DESCRIPTIVE REPORT

F00499

Descriptive Report to Accompany Hydrographic Survey F00499

Project OPR-Z486-NRB-04
Lake Superior-Duluth /Superior Harbor and Two Harbors, MN
Scale 1:10,000
July-September 2004
Navigation Response Team Six
Chief of Party: Kurt Brown, NOAA

Figure 1.1.1

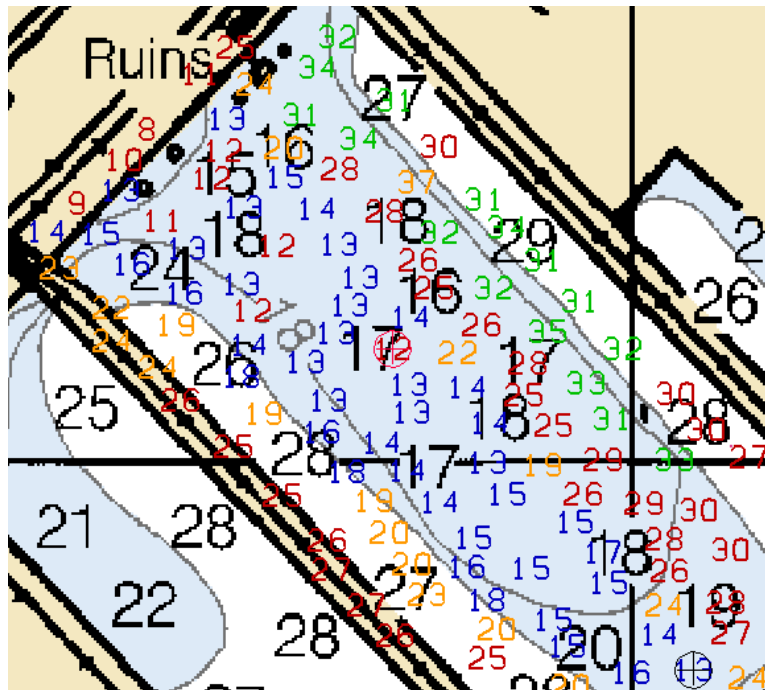
Survey Position: ~~046° 45' 02.050" N, 92° 08' 06.200" W~~ **46°45'02.04"N 92°08'06.18"W**
Least Depth: ~~3.84 m~~ **3.79m**
Timestamp: ~~2004-230-19:37:26.987 (08/17/2004)~~ **19:37:27.113**
Survey Line: duluth / 3001sb / 2004-230 / 060_1936
Profile/Beam: ~~838/1~~ **840/1**
Charts Affected: 14975_1, 14966_1, 14961_1, 14500_1

Hydrographer RecommendationsChart new depth. **Concur.** *See also page 5 of the Descriptive Report.***Cartographically-Rounded Depth (Affected Charts):**

Figure 1.2.1

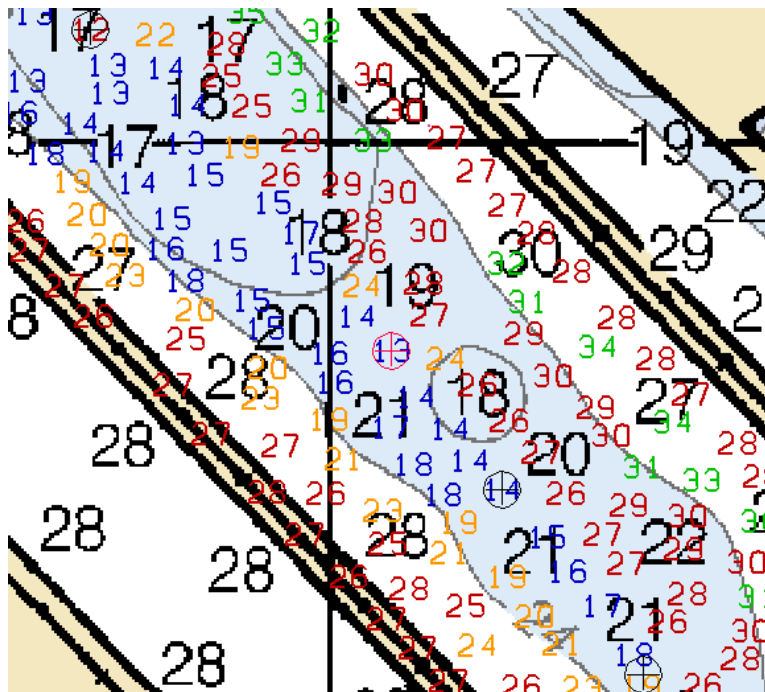
Survey Position: ~~-046°-44'-56.281" N, 92°-07'-58.352" W~~ **46°44'56.27"N 92°07'58.33"W**
Least Depth: 4.14 m
Timestamp: 2004-230.18:24:20.115 (08/17/2004) **18:24:19.929**
Survey Line: duluth / 3001sb / 2004-230 / 061_1822
Profile/Beam: ~~1671/1~~ **1668/1**
Charts Affected: 14975_1, 14966_1, 14961_1, 14500_1

Chart new depth. **Concur. See also page 5 of the Descriptive Report.**

Figure 1.3.1

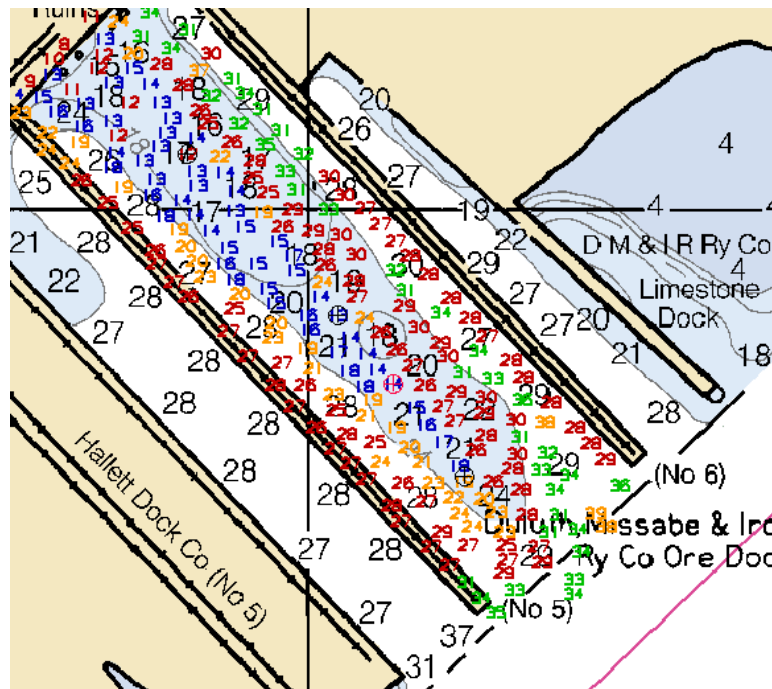
Survey Position: ~~-046°-44'-53.815"-N, -92°-07'-55.464"-W~~ **46°44'53.71"N 92°07'55.24"W**
Least Depth: ~~4.34-m~~ **4.31m**
Timestamp: ~~-2004-243-20:25:04.394 (08/30/2004)~~ **2004-230.18:21:19.495 (08/17/2004)**
Survey Line: duluth / 3001sb / ~~2004-243 / 070-2024~~ **2004-230/063_1819**
Profile/Beam: ~~497/1~~ **2043/1**
Charts Affected: 14975_1, 14966_1, 14961_1, 14500_1

Chart new depth. **Concur. See also page 5 of the Descriptive Report.**

Figure 1.4.1

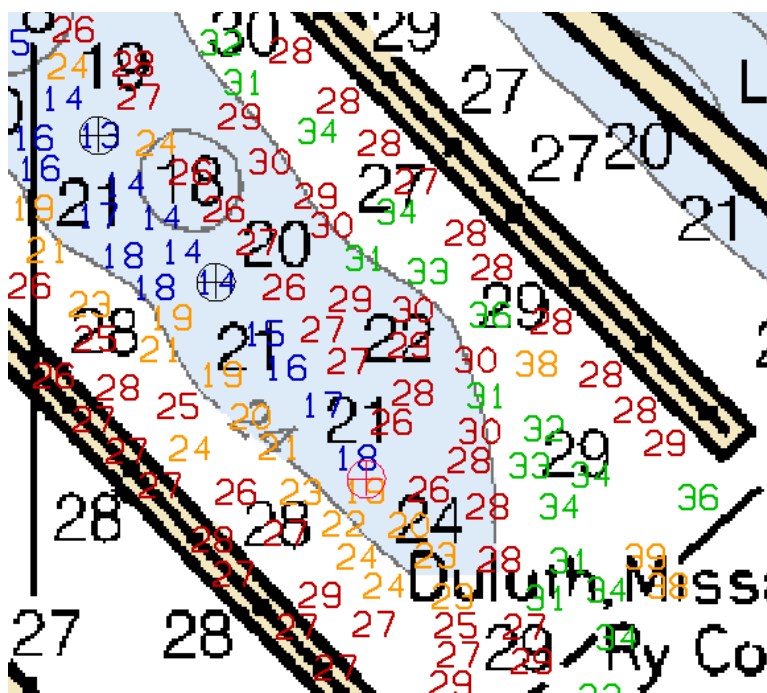
Survey Position: ~~046°-44'-50.487"-N, 92°-07'-51.786"-W~~ **46°44'50.74"N 92°07'51.84"W**
Least Depth: ~~5.71-m~~ **5.41m**
Timestamp: 2004-230.19:26:39.860 (08/17/2004) **18:15:58.502**
Survey Line: duluth / 3001sb / 2004-230 / ~~066-1926~~ **065_1815**
Profile/Beam: ~~430/1~~ **572/1**
Charts Affected: 14975_1, 14966_1, 14961_1, 14500_1

Chart new depth. ***Concur with clarification. Chart present survey soundings. See also page 5 of the Descriptive Report***

~~18ft~~ (14975_1, 14966_1) **17 ft**

~~3fm~~ (14500_1) **2 - 3/4 fm**

~~18ft~~ (14961_1) **17 ft**
